ADDENDUM NO. CC-2

NORTHEAST COMMUNITY COLLEGE WELLER BUILDING BASEMENT REMODEL
801 East Benjamin Avenue
Norfolk, NE 68702-0469
BCDM Project No. 3507-01

addendum

project name: Northeast CC – Weller Building Basement Remodel

2 LOWER LEVEL - LIGHTING
1/8" = 1'-0"

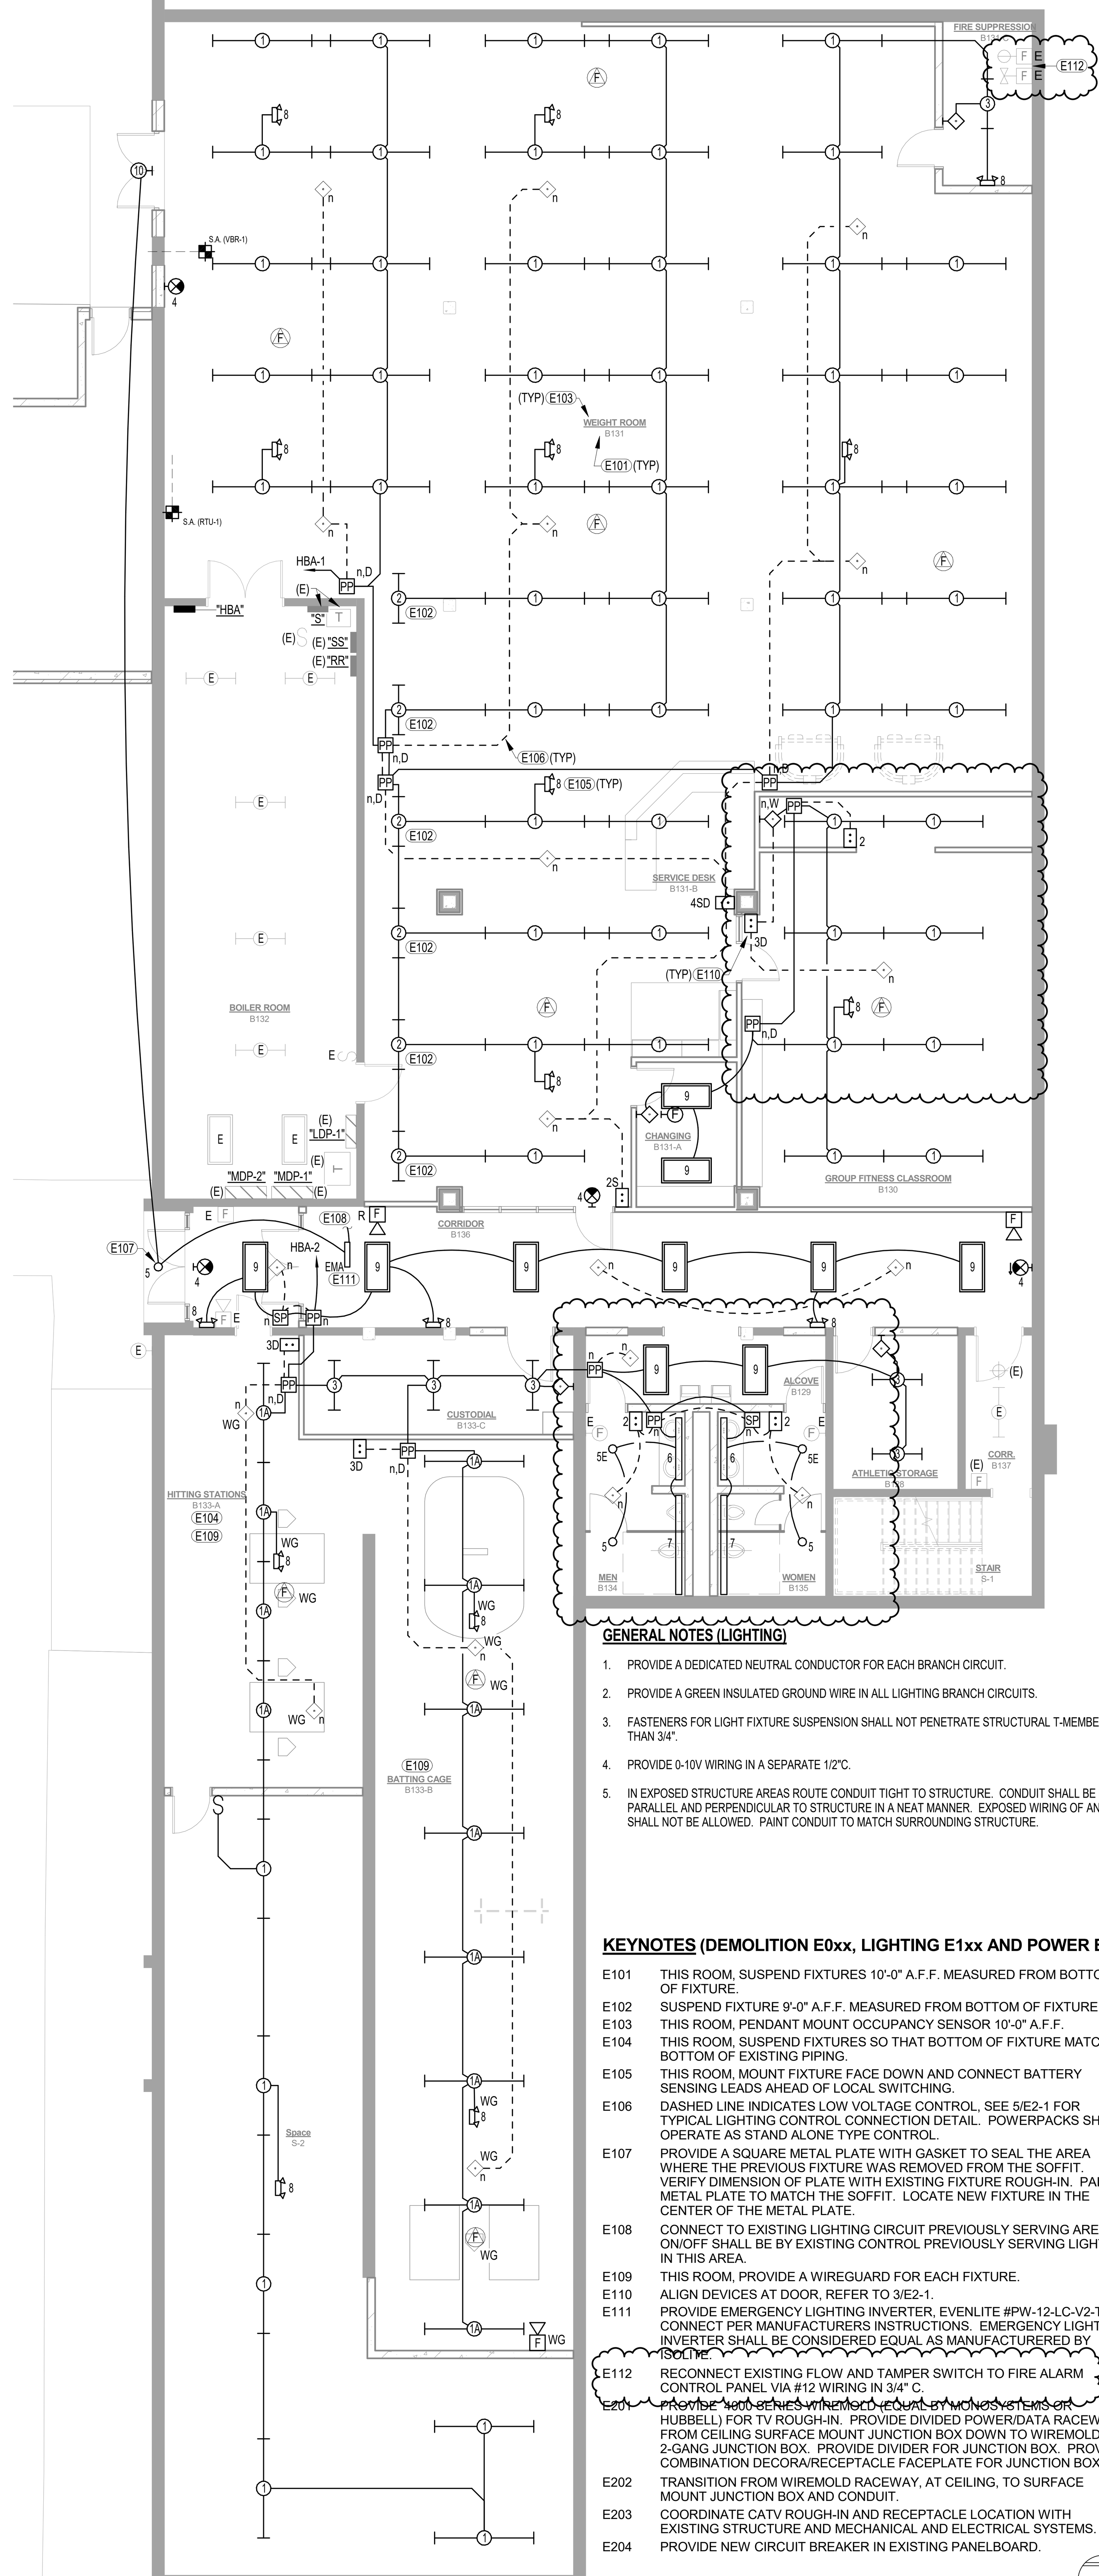
b. Modify lighting layout in Men B134 and Women B135. See 2/E1.1.
c. Modify lighting control in Group Fitness Classroom B130 and provide lighting control for small storage within room. See 2/E1.1.
d. Provide card reader rough-ins and door rough-ins in Corridor B136. See 3/E1.1.

1 LOWER LEVEL DEMOLITION PLAN - ELECTRICAL
1/8" = 1'-0"

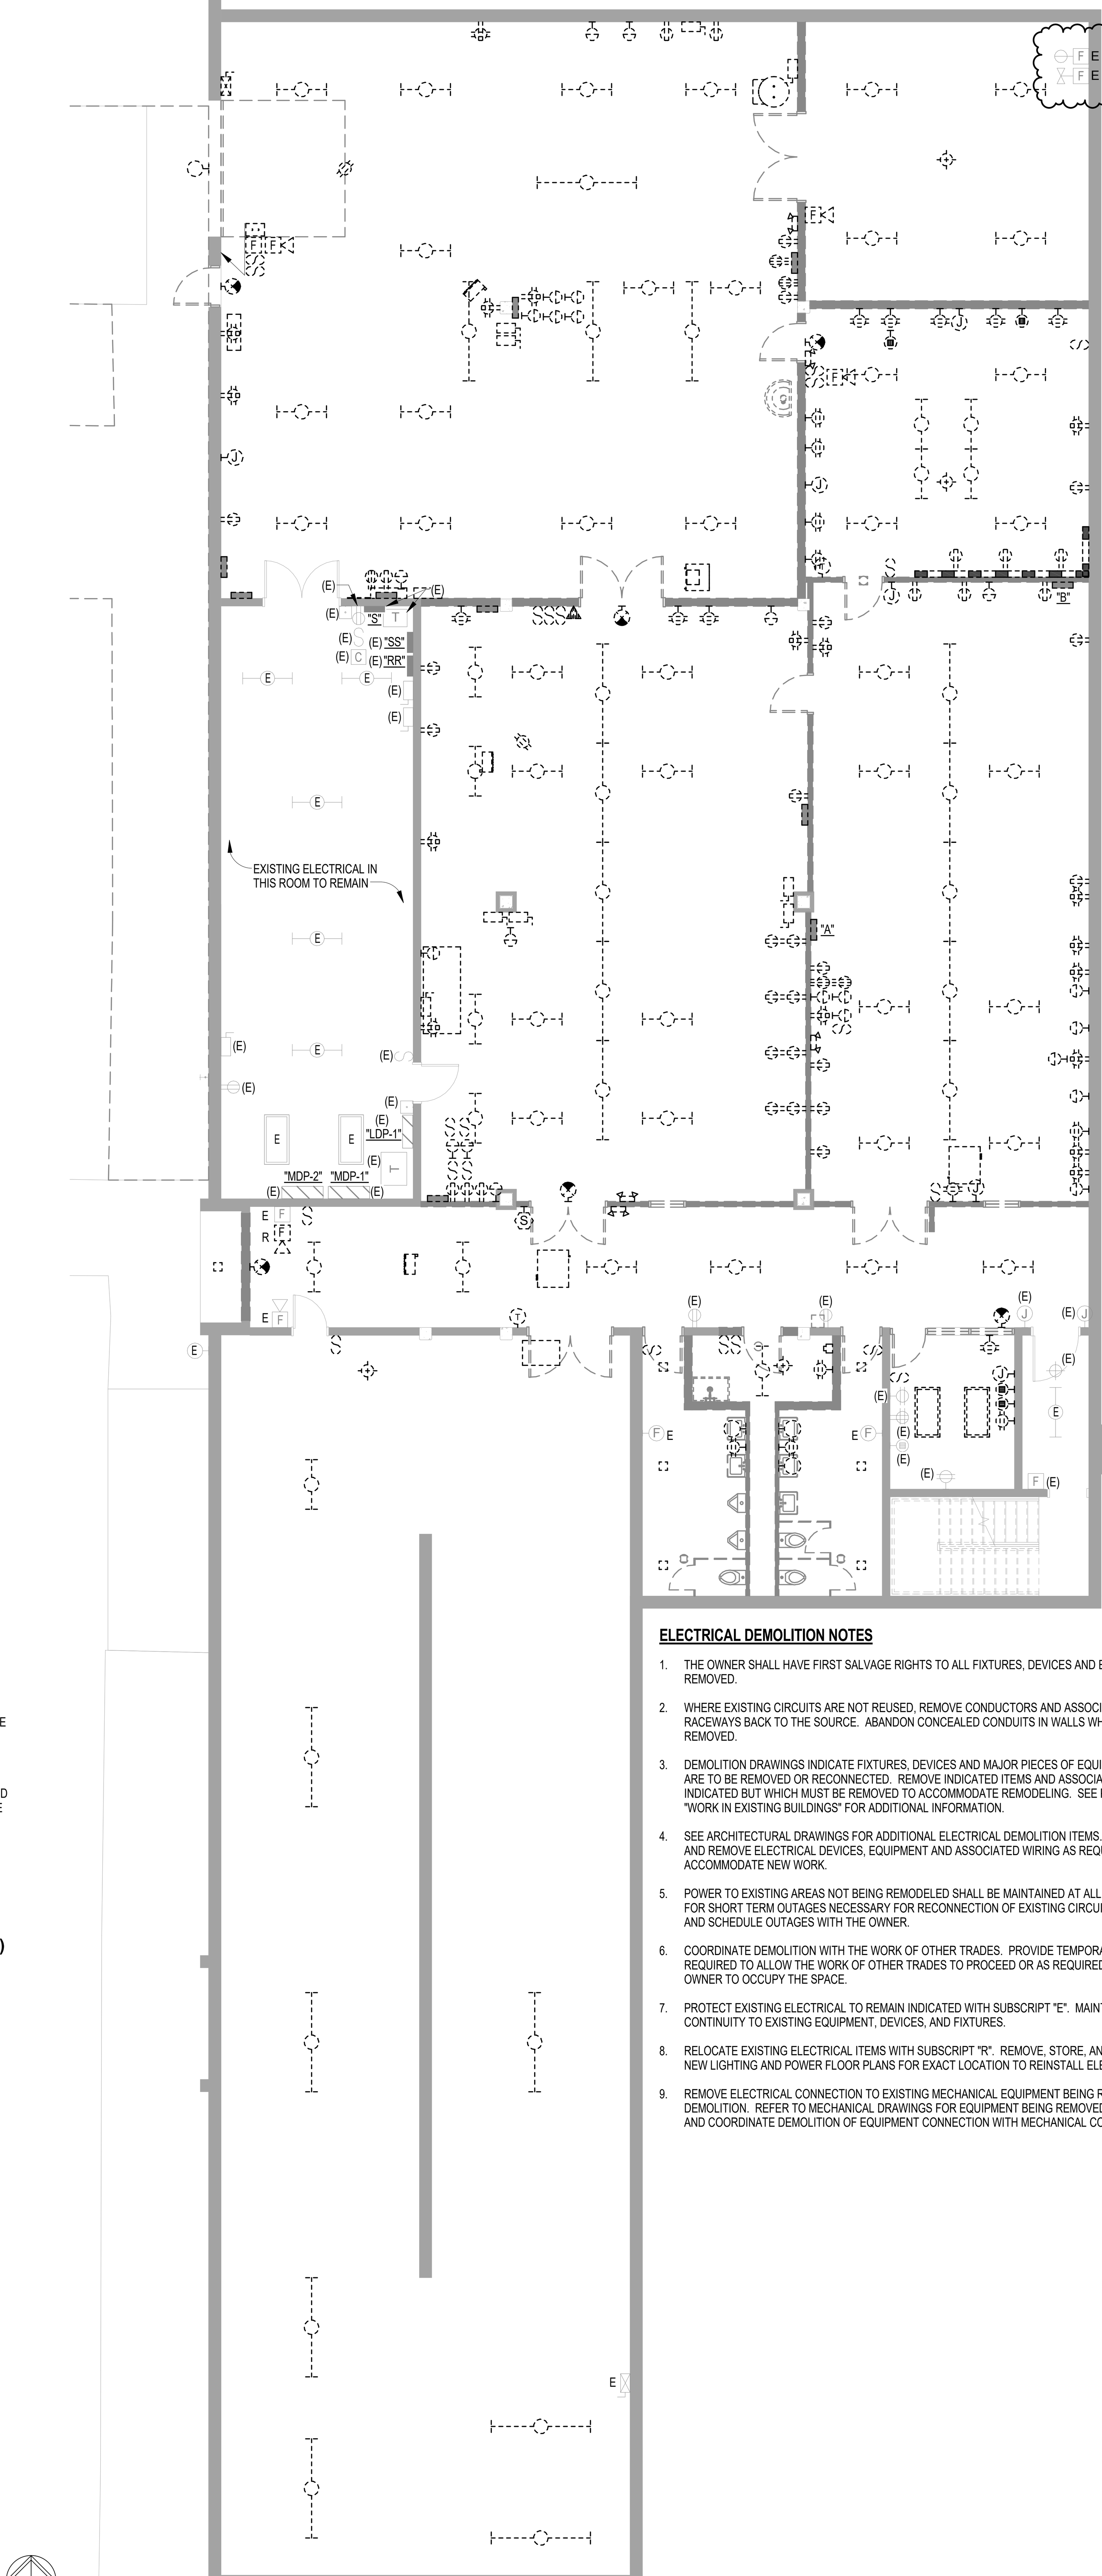
1. Sheet E1.1 – Electrical
    a. Reconnect existing flow and tamper switch in Fire Suppression B131 to existing building fire alarm. See 1/E1.1 and 2/E1.1.

6 AUTO OPERATOR DOOR ROUGH-IN DETAIL
NO SCALE

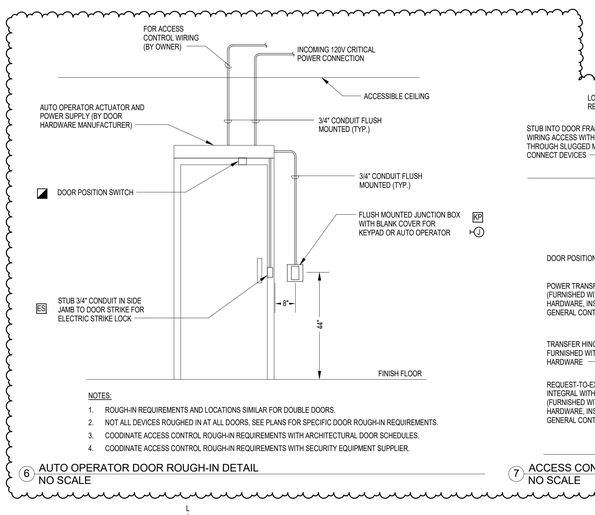
2. Sheet E2.1 – Electrical
   a. Provide card reader rough-ins and door rough-ins per details 6/E2.1 and 7/E2.1.
